Diesel Exhaust Fluid (DEF) Pressure Line Disconnected at the Doser Connection **49-019**

**Western Star Service
Bulletin**

Fig. 1, DEF Line Broken

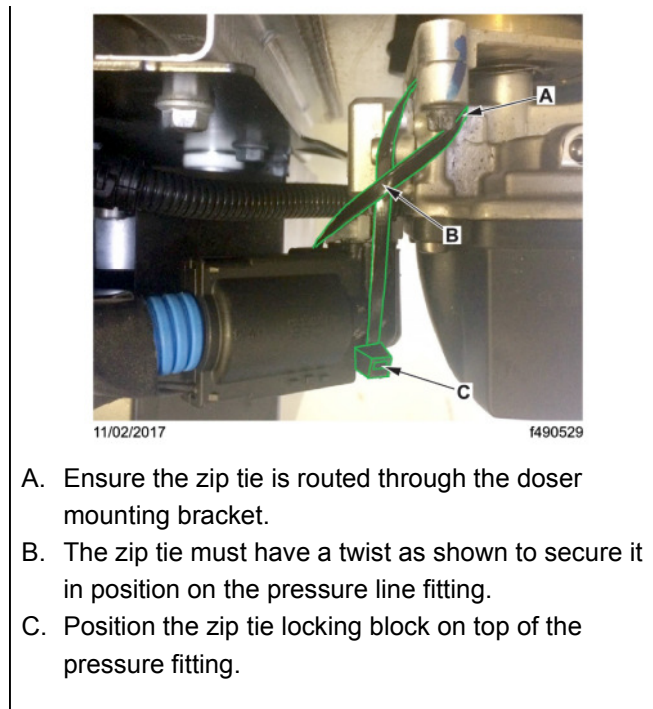
On some GHG14 and GHG17 vehicles equipped with a Detroit one-box aftertreatment system (ATS), the DEF pressure line may be pushed off the doser connection by frozen DEF in extreme cold climates. See Fig. 1 . Going forward, vehicles equipped with a Detroit Diesel one-box ATS will have a zip tie installed through the doser mounting bracket and around the DEF pressure line.

Installing the zip tie (part number 23-09796-509) prevents the DEF pressure line from being pushed off. The zip tie can be installed as a preventive measure or can be installed after the DEF line is disconnected, without replacing the DEF line.
